STANDARD AND TRIUMPH VEHICLES

No. SPORTS/4/M **REV. COUNTER CABLE FOULING OVERDRIVE RELAY** **Date** DECEMBER 1954

1 ILLUSTRATION.

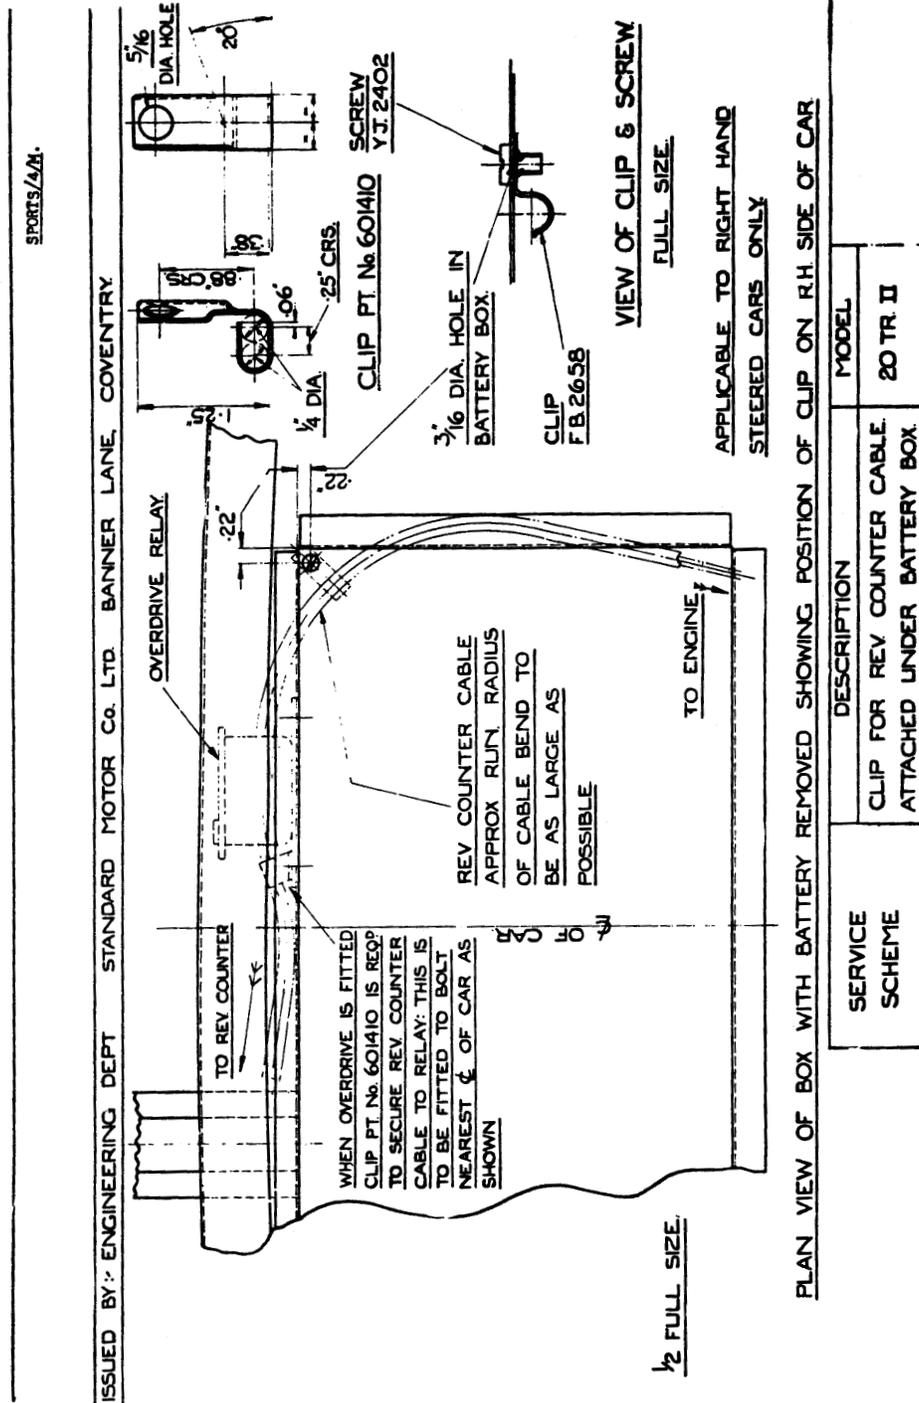
The Rev. Counter Cable was recently lowered in order to improve its "run." In its new position the cable was brought nearer to the relay, where overdrive is fitted, and thus introduced the possibility of an electrical "short" giving overdrive on all gears.

A new Rev. Counter Cable Securing Clip, Part No. 601410, is now fitted, and located on one of the relay securing screws and positioned so as to prevent electrical contact with the relay. The correct positioning of this clip is shown in the illustration.
